LOCATION: St Augustine Road, north of Haymarket Road**DATE FILED:** May 09, 2024**ZONING:** R-5(A), R-7.5(A)**CITY COUNCIL DISTRICT:** 8**SIZE OF REQUEST:** 65.9529-acres**APPLICANT/OWNER:** TMM Development, LLC

REQUEST: An application to create a 267-lot residential subdivision ranging in size from 5,000 square feet to 16,680 square feet and 5 common areas and one amenity lot from a 65.9529-acre tract of land in City Block 8717 on property located on St Augustine Road, north of Haymarket Road.

STAFF RECOMMENDATION: Section 51A-8.503 states that “lots must conform in width, depth and area to the pattern already established in the adjacent areas, having due regard to the character of the area, its particular suitability for development, and taking into consideration the natural topography of the ground, drainage, wastewater facilities, and the proposed layout of the streets.”

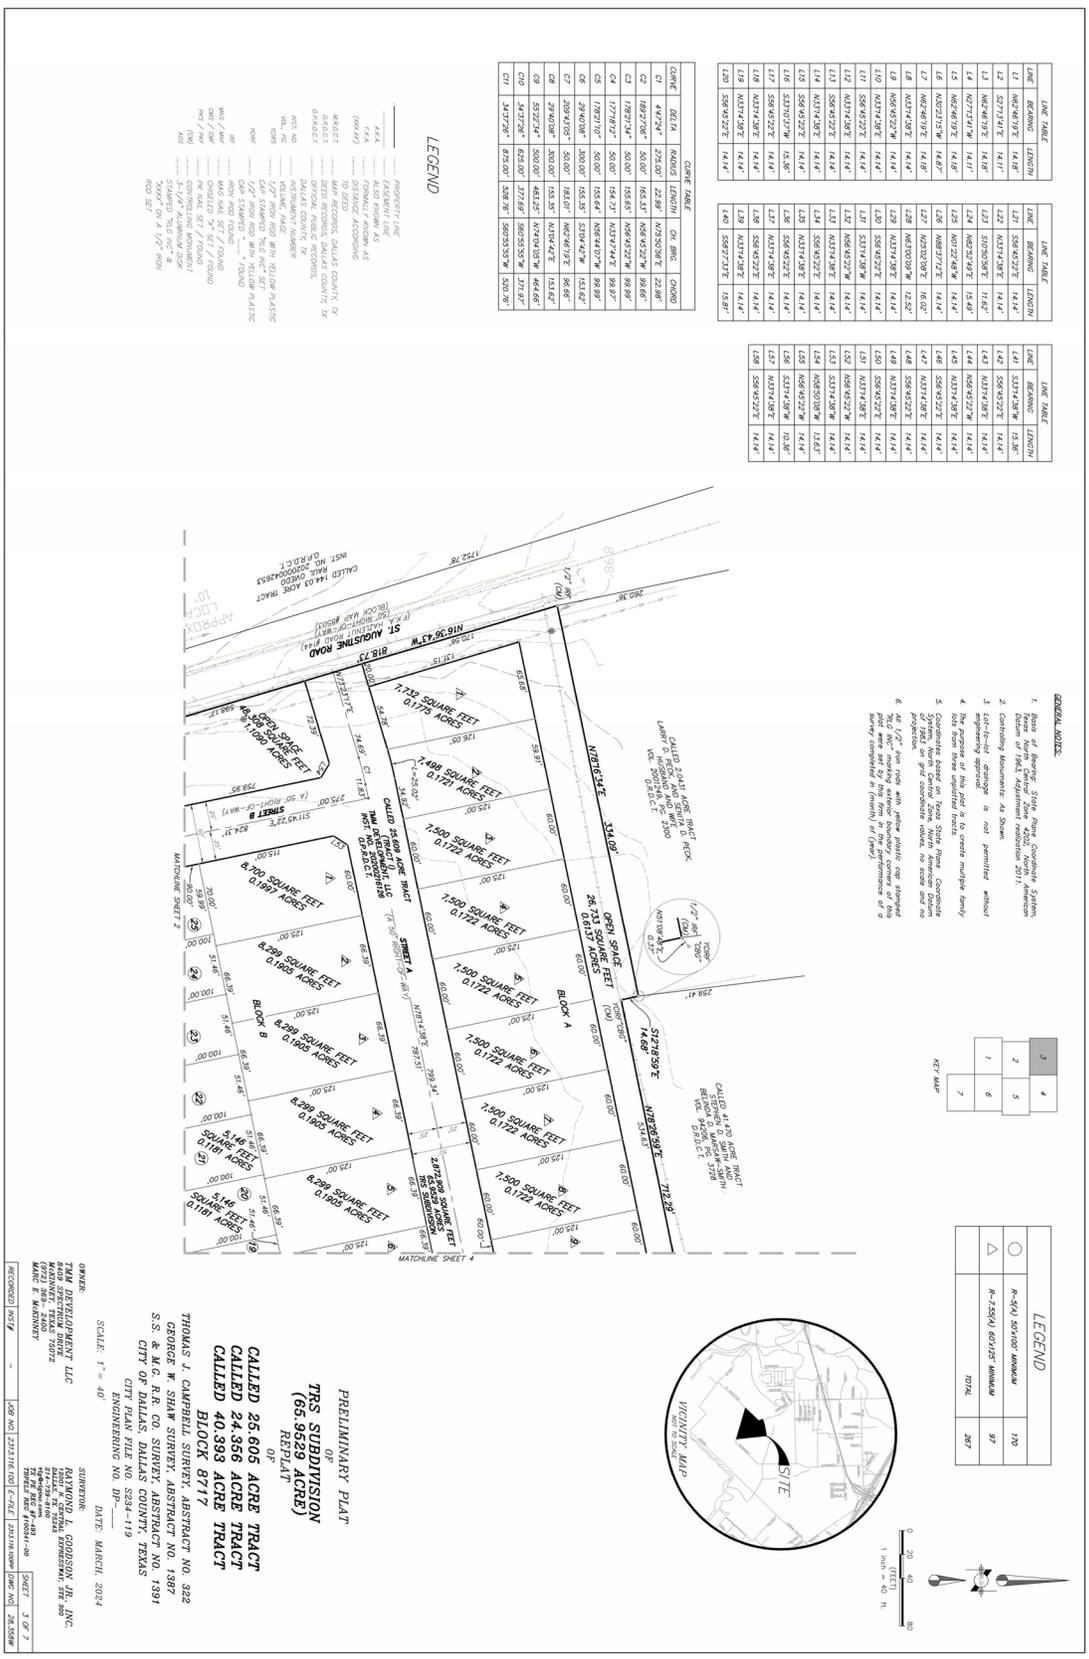
15. On the final plat, dedicate 30 feet of right-of-way (via fee simple) from the established center line of St. Augustine Road. *Section 51A 8.602(c)*

16. On the final plat, dedicate 30 feet of right-of-way (via fee simple) from the established center line of Haymarket Road. *Section 51A 8.602(c)*
17. On the final plat, dedicate 28 feet of right-of-way (via fee simple or street easement) from the established centerline of Streets. *Sections 51A-8.602(c), 51A-8.604(c) and 51A-8.611(c).*

18. On the final plat, dedicate a minimum 5-foot by 5-foot corner clip (via fee simple or street easement) at the intersection of Street H & Street N. *Section 51A 8.602(d)(1)*

19. On the final plat, dedicate a minimum 10-foot by 10-foot corner clip (via fee simple or street easement) at the intersection of St. Augustine Road & Street N. *Section 51A 8.602(d)(1)*

20. On the final plat, dedicate a minimum 5-foot by 5-foot corner clip (via fee simple or street easement) at the intersection of Haymarket Street & Street K. *Section 51A 8.602(d)(1)*

21. On the final plat, dedicate a minimum 10-foot by 10-foot corner clip (via fee simple or street easement) at the intersection of St. Augustine Road & Street A. *Section 51A 8.602(d)(1)*

30. On the final plat, change "St. Augustine Road (FKA Hazelnut Road #144)" to "ST. Augustine Road (AKA St. Augustine Dr. FKA Hazelnut Road FKA County Road No. 144).
31. On the final plat, change "Haymarket Road" to "Haymarket Road (FKA County Road No. 143)"
32. On the final plat, correct block number to 8771
33. Prior to the final plat, contact Addressing team for appropriate names for proposed right-of-ways.
34. On the final plat, identify the property as Block A/8769 through Q/8769.
